ECN/PCN No.: 4262

Product Description: Ceramic SMD Crystal	Abracón Part Number / Part Series: ABM3	<input type="checkbox"/> Documentation only <input checked="" type="checkbox"/> ECN <input type="checkbox"/> EOL	<input checked="" type="checkbox"/> Series <input type="checkbox"/> Part Number
Affected Revision: V	New Revision: W	Application: <input type="checkbox"/> Safety <input checked="" type="checkbox"/> Non-Safety

Prior to Change:

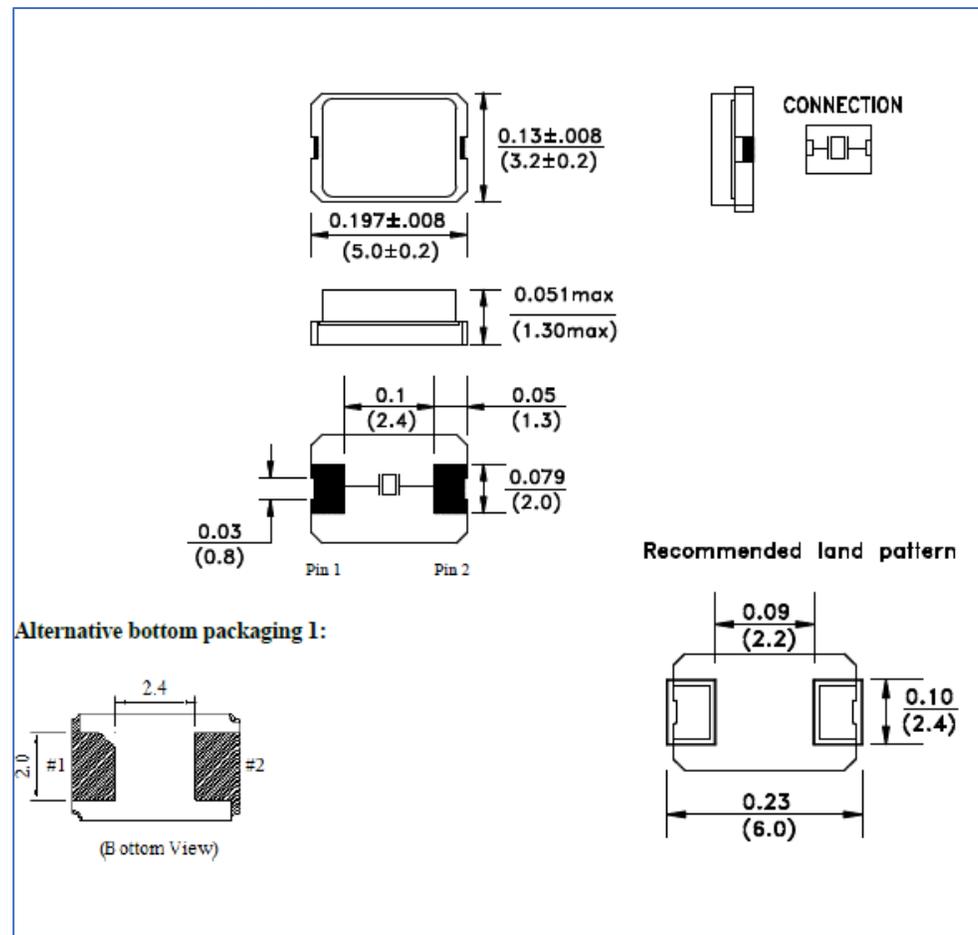
Abracon introduced additional manufacturing sources to ensure product availability and to be in a better position to meet long term customer demand. Added an alternative bottom packaging structure to reflect the product produced by all manufacturing sources.

After Change:

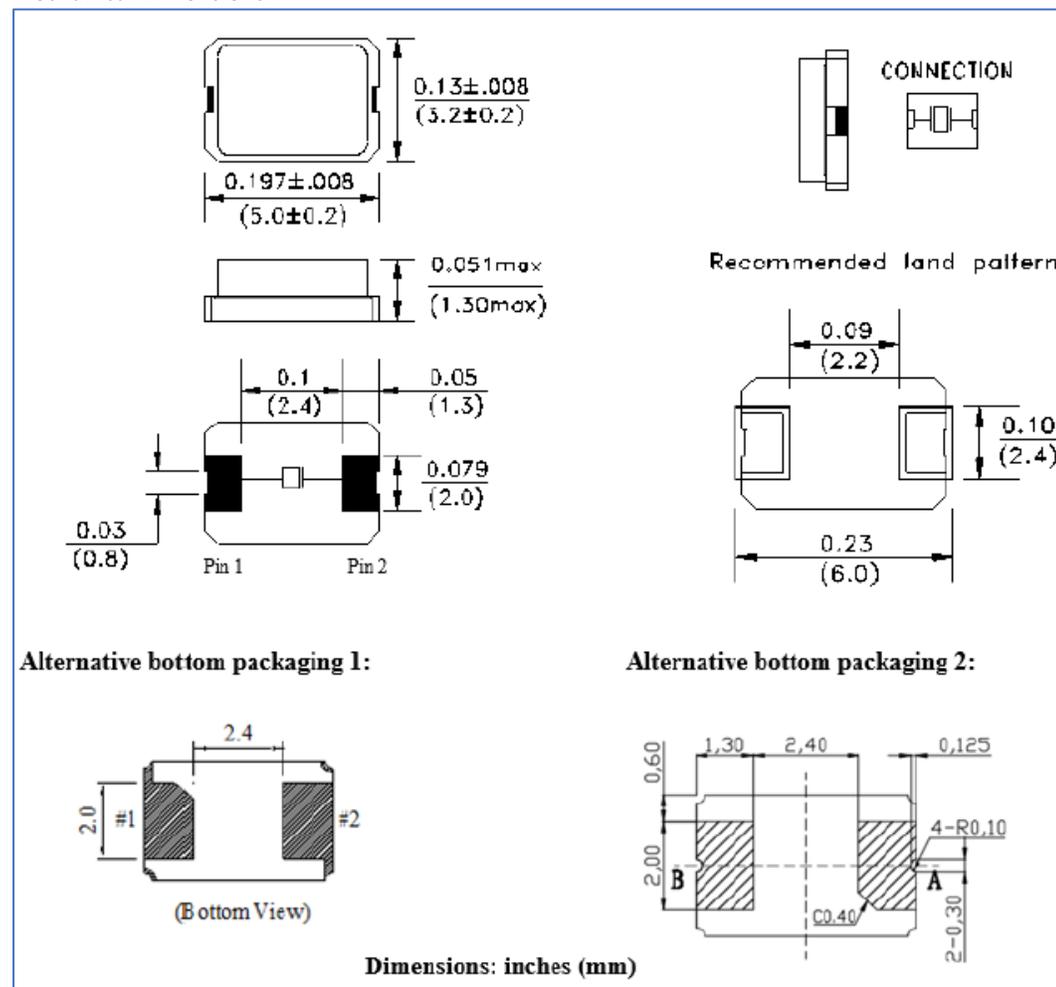
Change Declaration:
The added bottom packaging structure does not impact the electrical performance of the device.
